**Seattle  
Design  
Commission**

**MINUTES OF THE MEETING**

**March 6, 2008**

Projects Reviewed

**Figure 3: Site Plan**

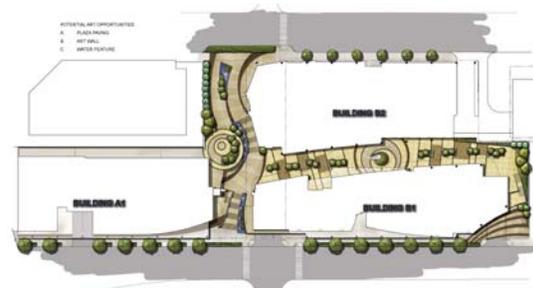
- **Appreciate the well designed plaza and stairs which are more prominent and visible than before.**
- **Curious about the art elements and urge the team to involve an artist in these early, critical phases of design**

- **The roofs are a considerable part of the view corridor and treatments, such as green roofs, should be considered.**
- **The garage entry seems uncomfortably large and the team should consider reducing the number of lanes.**

- **Review the sidewalk treatment through the driveway entrance to make sure the pedestrian environment is clearly delineated.**
- **The ratio of green to pavement seems skewed to the hardscape, recommends more balance.**

- **Incorporate more pausing space within the context of the large scale stairs and create a “balance of choices” to enhance the pedestrian experience.**

- Are there plans to regularize 8th Ave?
  - Part of work with SDOT is to look at that swath of asphalt. Two realignment studies are underway.
- Is the project developed sufficiently to approve the public benefit? Although the retail space is appreciated, the focus should be on public benefits.

- Can there be two lanes of traffic exiting the parking rather than three?
  - Currently working with traffic engineer, do not want to impact the traffic light. The entrance/exit is also important for retail.

- Perhaps the team can look at pavement treatments for this area.
  - Have incorporated elements to soften that edge, but also opening it up to daylight.

- The amount of green vs. pavement is not balanced. Stairway is large compared to actual use by people. More of a visual than an actual use.
  - The steps were made broad enough so people can sit on them. In addition, the Design Review Board wanted the staircase to be open.

- The space doesn't look as relaxing as it could be
- Examples include Two Union and 1660 Eastlake, which is wonderful.
- Seating opportunities are a great idea, but a balance of choices is important. Many plazas and steps, but nothing between.

- The thinking is to provide movable seating opportunities like 1660 Eastlake.
- The east building has moved to have a lower podium/pavilion. Also moved building A1 south a bit. Have kept main volumes of structures.

**Figure 12: Previous and Current Plaza Design**

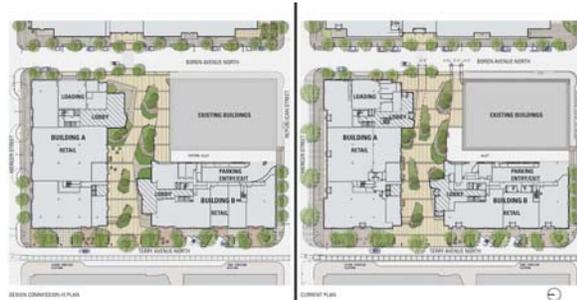
- **Greatly appreciate the style and content of the presentation, with before and after images and addressing previous Commission concerns including increased openness at Boren and Terry, relationship to Mercer St and the balance of public and private**

- **Appreciate the dynamism and scale of the art pieces with activity that will invite public interaction and touch and greatly encourage the art stepping out into the public ROW.**

- **Scale of the paving seems large. Possibly look at including finer textures or increased frequency of score joints, and also its relationship to the island elements.**

- **Encourage better placement of bike racks within the plaza in relation to art pieces.**

- Why screen private activity from the public experience? Enlivening the space depends on the interaction between the private and public.
  - Screening is used only where it will enhance the public experience, not along streets.

- What is the pavement?
  - Concrete scoring.
- May have more scoring than every 30ft indicated
  - Understand this and will respond to it.
- Islands are independent of the pattern, may want to think how they interact with the paving.

- Landscape island element fits well with art piece functionality.
- Oasis of good public space within the courtyard.  
Confused about island heights and where the sculpture is located.

- The island where the art is located goes from 2ft to the ground plane. The piece will be elevated off the bench.
- The public art is a private element of art in a public setting and encourage it setting out into the public right of way, correlates with the design guidelines of Terry. Support interactive qualities of the art piece.
